**DATE:** September 14, 2017

**TO:** Santa Fe County Planning Commission

**FILE REF.:** CASE # V 17-5160 Prabhu Khalsa & Regina Spamer Variance

Prabhu Khalsa and Regina Spamer, Applicants, request a variance of the Sustainable Land Development Code Ordinance 2016-9 (SLDC) Chapter 7.17.9.3.2, governing height of a structure, to exceed 18' on a ridgetop, and to allow a two story residence on a ridgetop, and a variance of Chapter 7.17.9.2.4 to allow a driveway to disturb 30% slope to access a buildable area.

DRIVWAY PLAN AND PROFILE

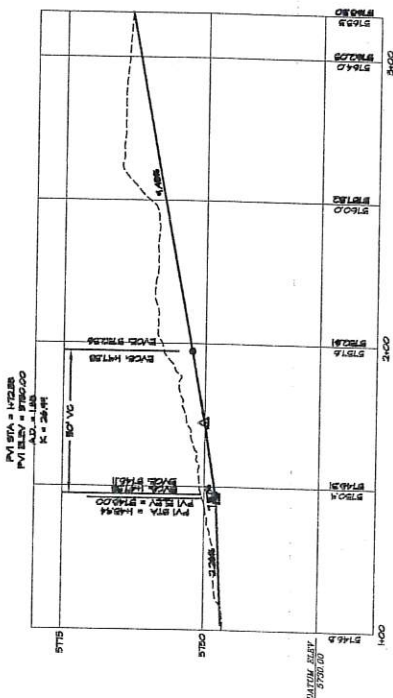
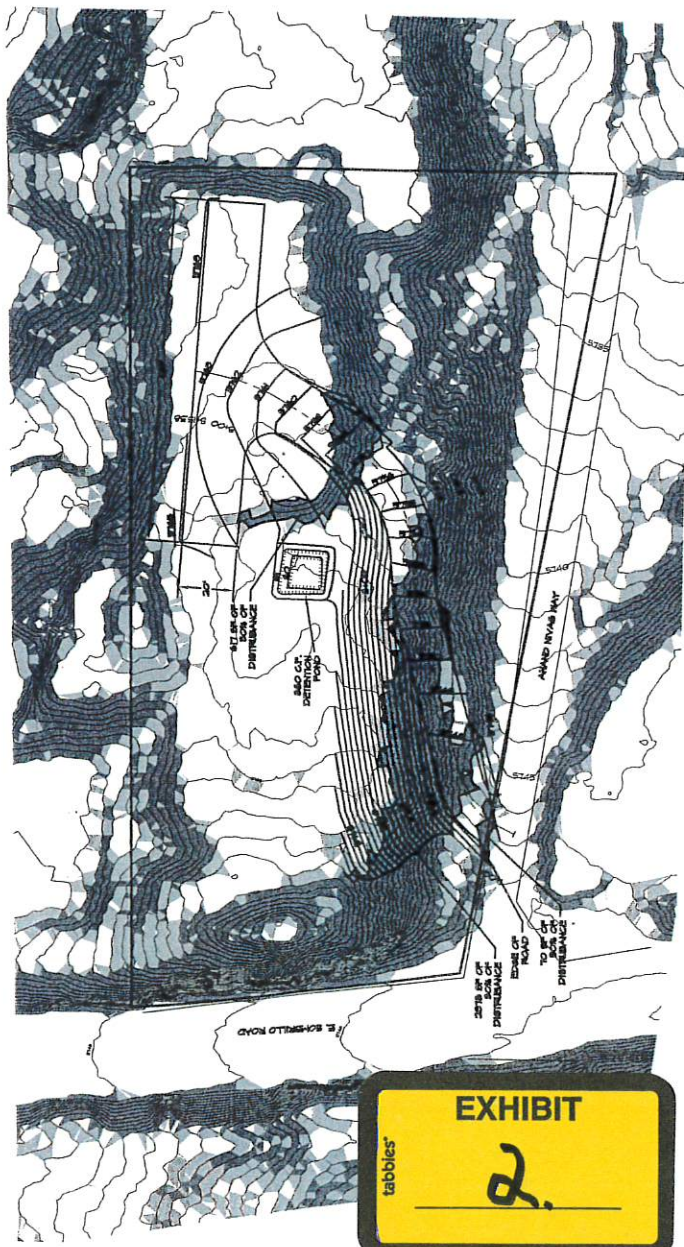
**Staff Response:** Staff has conducted an inspection on the property and concurs with the Applicants. There is no other access to the buildable area on the property without disturbing 30% slope while also being able to meet grade requirements.

**Staff Response:** Staff has reviewed the Applicants' Grading and Drainage Plan and has determined that there is no other possible way for the Applicants to meet the requirements of the SLDC. Terrain creates a hardship to the Applicants and the selected route for the driveway is the only access to the buildable area of the property.

**Staff Response:** There is no other access to the property and disturbance of slope is a necessity to access the buildable area.

**Disturbances:** Staff recommends approval of the variance for slope disturbance. The Application is not in strict compliance with the SLDC, but this Application meets the criteria necessary for granting a variance. Due to the topography of the lot, the Applicant is unable to build a home on their lot without a variance. Criteria 1, is that the request is not contrary to the public interest. The request meets this criteria as the site offers limited buildable area. The inability to build on the property due to the requirements in Chapter 7, Section 7.17.9.2.4, demonstrates that they have met the variance criteria where due to extraordinary and exceptional situations or conditions of the property, the strict application of the code would result in peculiar and exceptional practical difficulties or exceptional and undue hardship on the owner. The terrain on this property consists of steep slopes, and minimal buildable area. In order to construct any residence on this property a variance request is necessary. This causes peculiar and exceptional practical difficulties or exceptional and undue hardship on the Applicant/Owner, which meets Criteria 3, that the spirit of the SLDC is met. Therefore, staff recommends approval of the Applicants' request for the variance.

DESCRIPTION  
Elevations

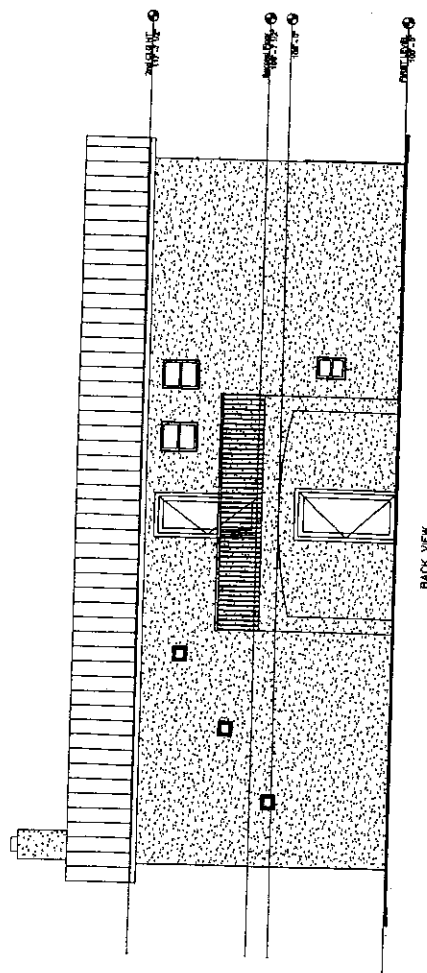
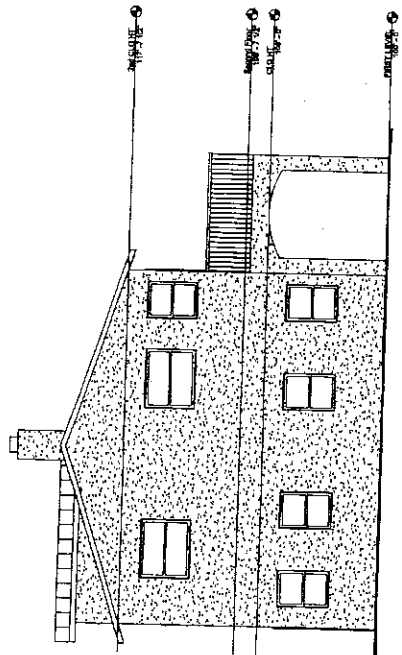
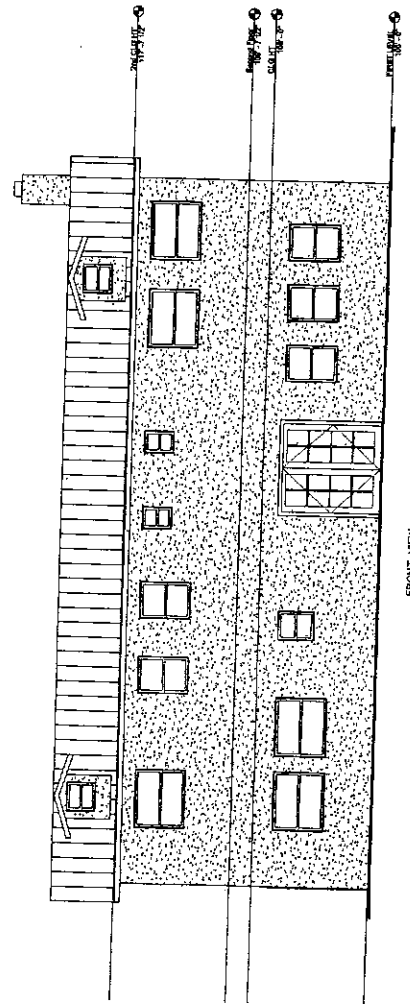
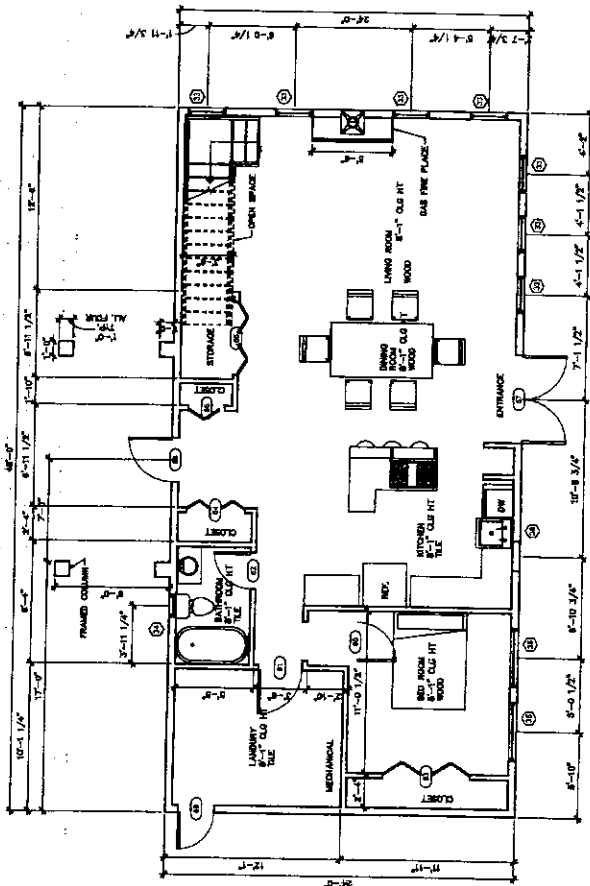
**Staff Response:** Although there are existing 24' two story homes in the vicinity, those homes are not on a ridgetop and do not have to meet height limitations of 14' flat roof or 18' pitched roof with a single story design. This property is located on a ridgetop and is limited by the SLDC to one story and is subject to Chapter 7, Section 7.17.9.3.2, which restricts structures on ridges, ridgelines and shoulders to fourteen (14') in height and limits them to be one story. This section does allow for a structure on a ridge or ridgeline that is a one story pitched roof to be no more than eighteen (18) feet in height, so long as it is screened from view from an arterial or major arterial road.

**Staff Response:** The fact that the Applicants designed a two story home is not grounds for granting a variance. The site contains a buildable area of 4,000 square feet in which a one story structure can be placed. The applicant can build an 18' pitched roof with a south facing façade to allow for southern exposure which will allow for sunlight to enter the building. The Applicant can place skylights along the southern pitch and keep the structure at 18' to allow additional southern sun exposure to enter the residence. The structure can allow for a 14' flat roof and remain one level while other rooms that don't have sunlight entering can have an 18' clear story pitched roof to allow for windows and sun light for an effective passive solar design. The site contains ample room for a one story house of the same size.

**Staff Response:** The surrounding residences are not located on a ridgetop and are not restricted to the same requirements as this property. The proposed structure is subject to current standards and shall not exceed 14' in height for a flat roof residence or 18' pitched as required by Ordinance 2016-9, the SLDC. This residence can be designed differently with a one story design and remain consistent with the SLDC. Granting this variance creates a possible precedent for surrounding properties where development is proposed on a ridgetop in this area as well as other communities in Santa Fe County.

**Height:** Staff recommends denial of the requested variance for height. The Applicant's 22' residence exceeds height requirements of the SLDC which allows a 14' one story flat roofed residence or 18' pitched roof one story residence. The Applicant can create an alternative design so the structure meets height requirements

**Two story:** Staff recommends denial of the requested variance for two story. Structures on ridges, ridgelines, and shoulders shall be limited to one story structures. The Applicants' proposal does not meet requirements of the SLDC; surrounding properties are not located on ridgetops and there is space for the Applicant to build the same size house as a single story with an alternative design to allow a solar passive residence.
